Reviewers' comments:

Manuscript ID: NCOMMS-19-28963-T

Carbon footprint of global natural gas supplies to China

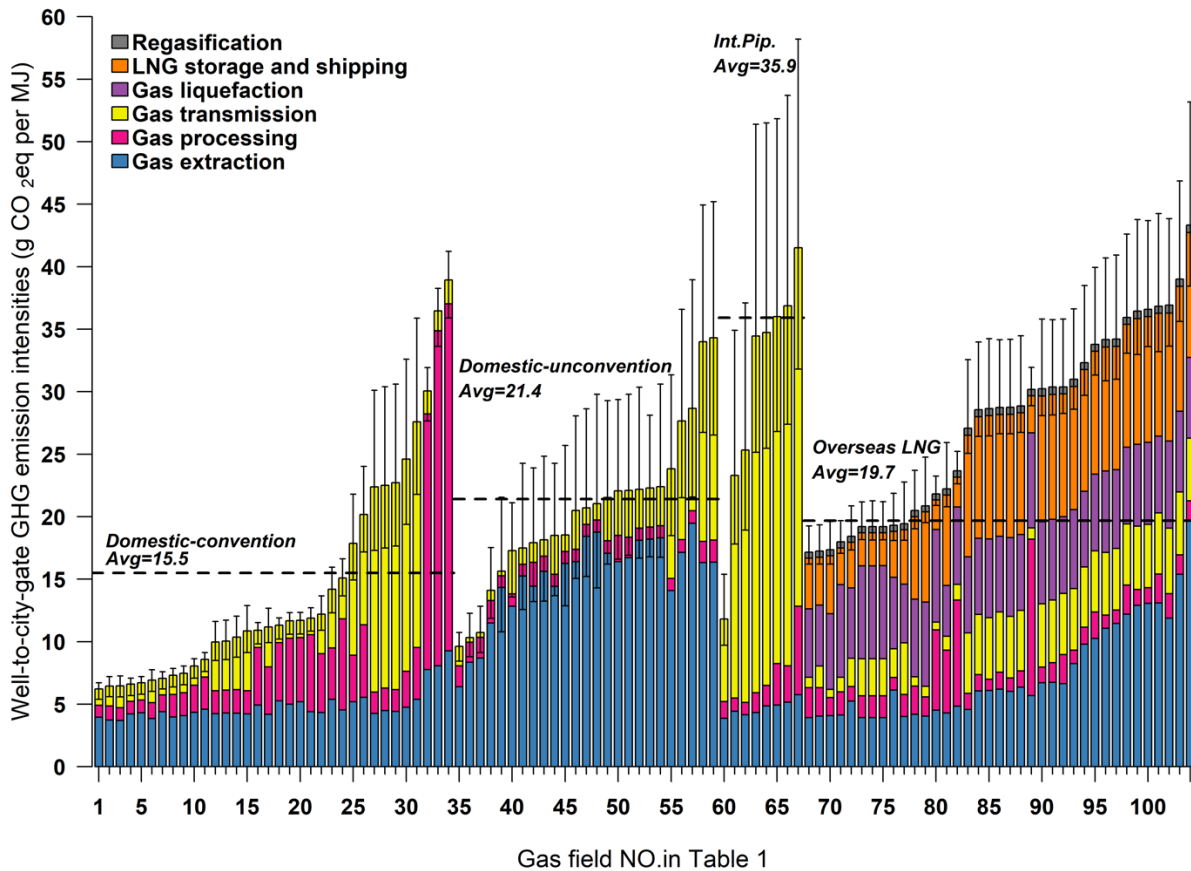
(3) There are significant uncertainties around GHG intensities for Chinese gas supplies both at the present

3) The color schemes of figures 1, 2 and 4 are a bit harsh on the eye, perhaps pastel versions of the same colors can be used to improve the aesthetics.

We added error bars in Fig.1, Fig.2, and Fig.4 to present the uncertainties of the results. We also added a section of uncertainty analysis to present the detailed calculation methods and data sources in SI I.

Fig.1 was revised to:

Response: Thanks for the suggestion. We have changed the color schemes of figures 1,2 and 4 according to the reviewer's comment.

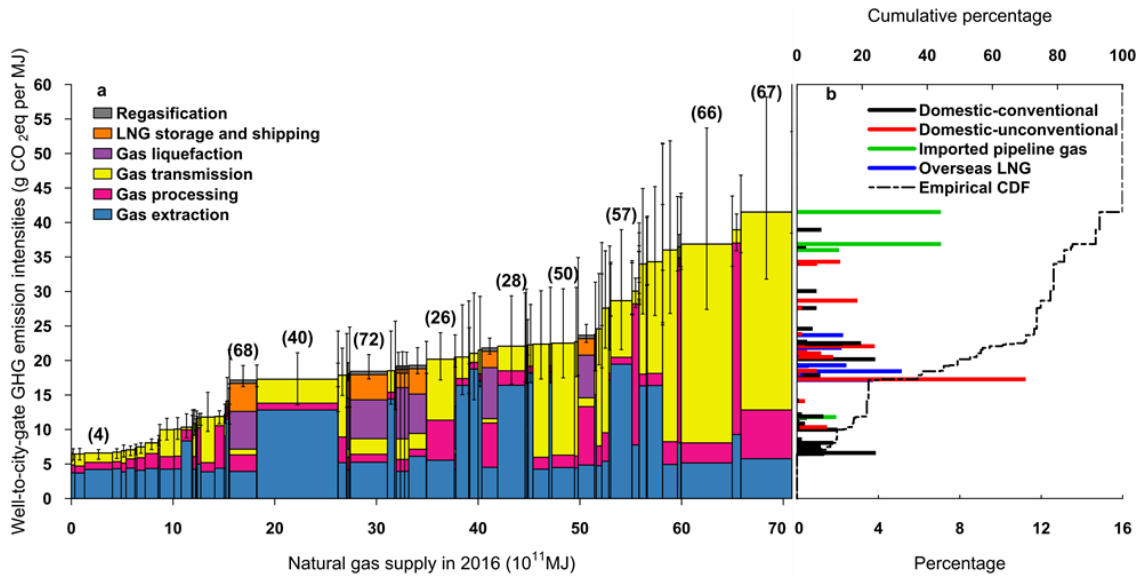
6) Please add a little spacing between parts A and B of figures 2 and 4.

Fig.2 was revised to:

Response: Thanks very much for the suggestion. We have added some spacing between parts A and B of figures 2 and 4 in the revised manuscript.

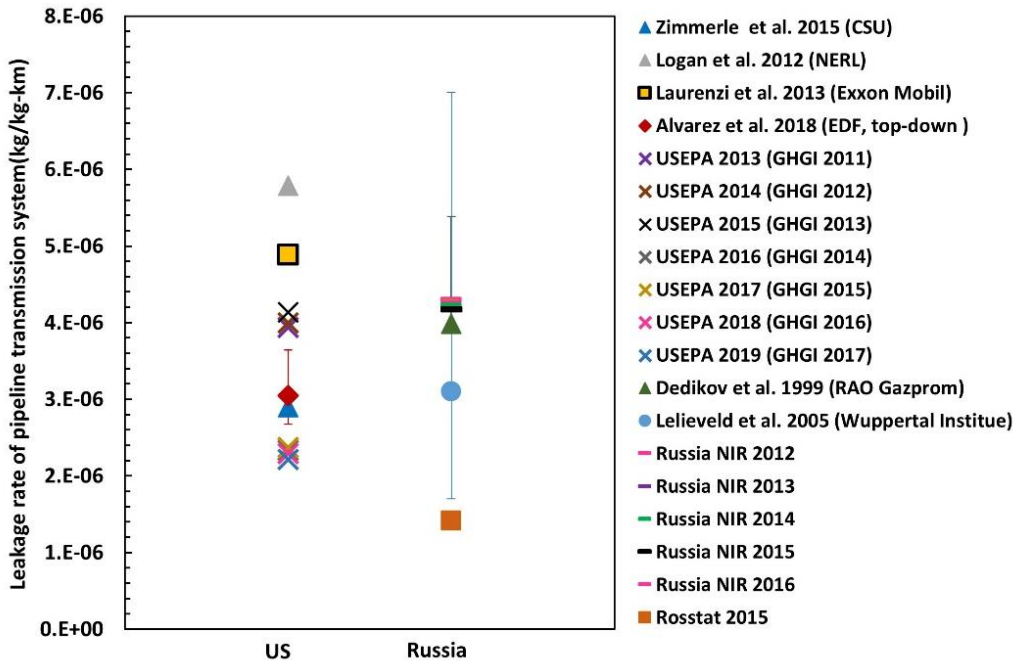
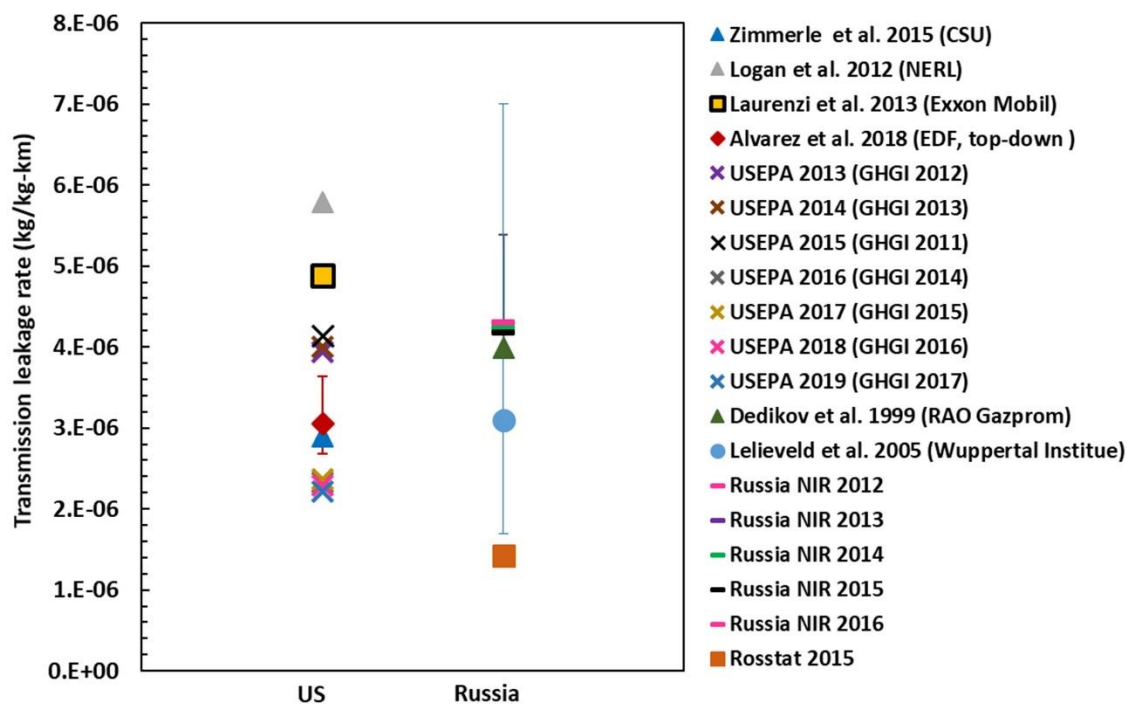
2) One of the strong points of this paper is the use of region-specific data with regards to gas composition and pipeline length. Unfortunately, as stated on lines 127-128, the leakage rates from pipelines are generic rather than region-specific. This is a shame because, this is both one the most critical variables and it is also a variable that is likely to show a high degree of variation across regions. I don't think the +/- 20% used in the sensitivity analysis does justice to this variation. I think the pipeline leakage rate is likely to show a much higher spatial/technological variability than that. This is a flaw that is not easily corrected without gathering additional data. Still I feel that the paper needs to address this issue in a much more comprehensive way before it can be published in Nature Communications. It is crucial to know this because much of the added value of the paper lies in reducing the uncertainty in China's future natural gas footprint. Without having a much better view on the uncertainty in pipeline leakage, it is impossible to judge to which extent the overall uncertainty is reduced.

Fig. S5 summarizes literature estimates of the pipeline leakage rate for the U.S. and Russia. Noteworthy, we have converted the percentage leakage rate of throughput to the leakage rate on per kilometer (km) of transport distance basis. The lengths of the U.S and Russian pipeline system that used for conversions are obtained from the literature. Studies of Russia's pipeline system leaks are focused on Russia's export corridors to Western European. The length of the export corridors is ~3000 km within the Russian border (the distance of Northern Corridor is 3075 km while the Central Corridor is 3376 km)[2,11]. The average transmission distance of the U.S natural gas system was estimated at ~1000 km[21-24]. The much longer transmission distance of Russia's natural gas system leads to its higher leakage rate in terms of percentage throughput than that of the U.S. system in literature[7,10,11]. Yet on the per km basis, pipeline leakage rates of the two systems are comparable and their uncertainty ranges overlap mostly, as shown in Fig. S5.

A section about uncertainty analysis was added as Section 3 in SI I, and the first part of the section is about the uncertainty of the pipeline leakage rate. In the section, we summarized the uncertain estimate of pipeline leakage rates for the U.S. and Russia systems from literature and used them to calculate the pipeline leakage for gas transmission in the U.S. and Russia, respectively. We discussed the potential reasons for the variations in the pipeline leakage rate. Because there is no publicly available data on the leakage rate of China's pipeline system. We analyzed the characteristics of China's pipeline system that might be related to the leakage rate, including pipeline age, operating pressure, level of maintenance, and compared to those for the U.S. and Russia's pipeline system to obtain information for the uncertain estimations about China's pipeline leakage rate.

Fig. S8 Delivered ex-ship (DES) price of LNG imports for China in 2019.
Data source: Shanghai Petroleum and Gas Exchange (SHPGX)[52]

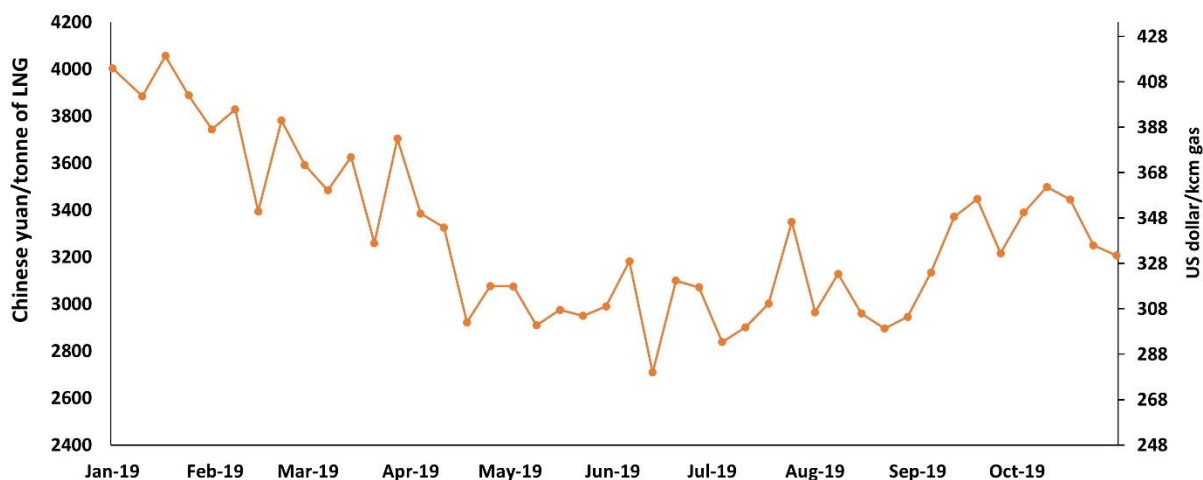
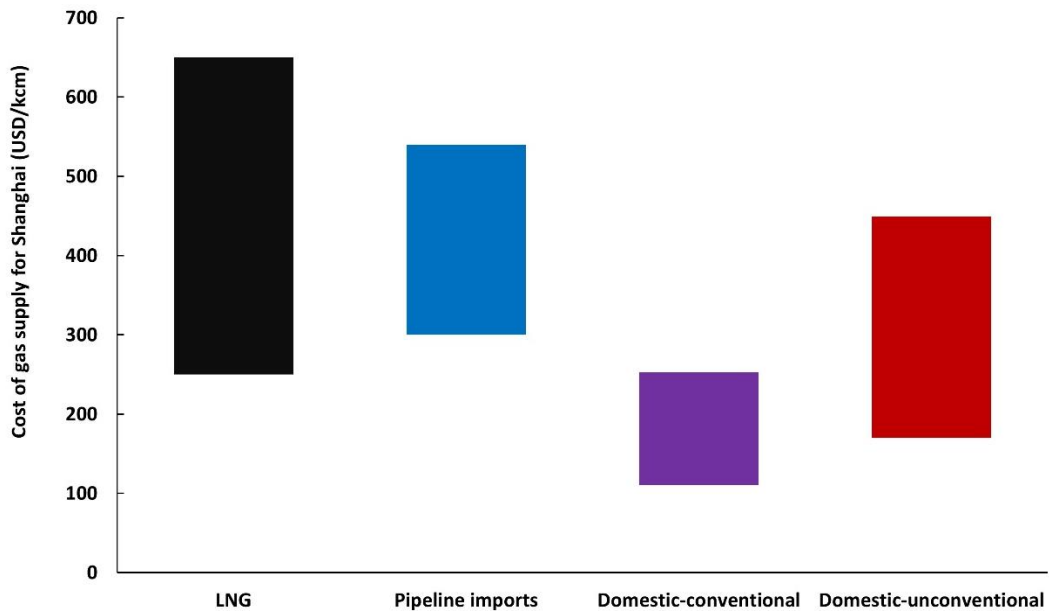
(4) The authors acknowledge that a major weakness of their study in terms of the projections out to 2030 is the absence of economic analysis. That is clearly difficult in a country like the Peoples Republic of China (PRC) that retains elements of a planned economy.

gas supply curve for 2030 based on China's current anticipation of domestic production, signed and expected import contracts. Through the analysis of the projected supply curve, we aimed to identify the potential hotspots and underlying driving force for the GHG emissions and thus provide suggestions on emissions reductions for decision-making and natural gas industry development in China. Besides emissions reduction pressures, China's natural gas supply strategies are affected by a variety of factors, including geopolitical relationships, energy security concerns, and economic factors. Analyses of these factors were beyond the original research scope of the study. In the revised manuscript, a section of economic analysis was added in SI I to provide some discussions on the economic aspect:

Fig S10 compares the supply costs of different sources of gas supply to Shanghai. Due to the lack of public data from natural gas production sector and the involving international gas market, high uncertainty exists in the estimations of natural gas supply costs.

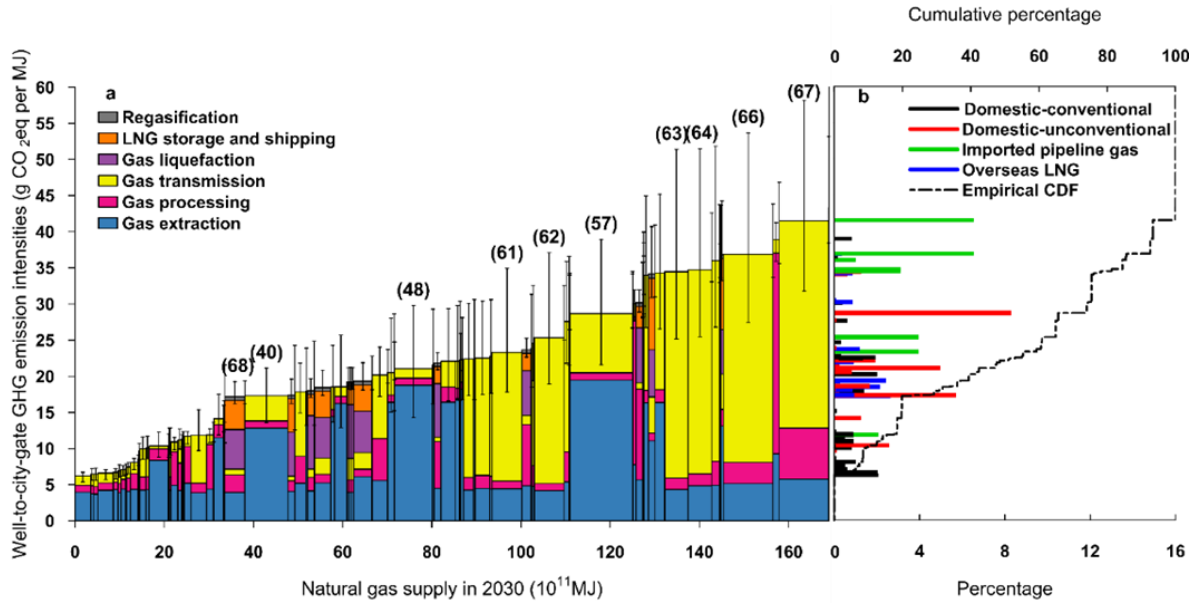
Main points to be improved:
1) In its current form the paper focuses quite heavily on the technical aspects, while under-representing its relevance as climate mitigation measure. The main result of the paper is that the upstream emissions of natural gas delivered to China are expected to increase from 21.9 g CO2eq/MJ in 2016 to 23.7 g CO2eq/MJ in 2030; which according to the authors might undermine the effectiveness of China's coal-to-gas switch strategy (lines 31-33). It is difficult for the reader to judge how much effect this has on the total GHG emissions in 2030 in China. I would expect that the effect is actually relatively minor and that the benefits of shifting from coal to natural gas greatly outweigh the slightly larger upstream emissions for Natural Gas. The authors can consider

to add a figure with the future trajectory of China's total GHG emissions per year with the current CO_2 intensity of NG and the effect of taking into account the future developments in supply.

Response: Thanks very much for the suggestion. We have accepted the reviewer's suggestion and added a figure with the projections of the GHG emissions reduction benefits of China's coal-to-gas switching under different scenarios of GHG intensities of natural gas supply. And thus we demonstrated the importance of analyzing and reducing the upstream emissions of gas supply for global warming mitigations.
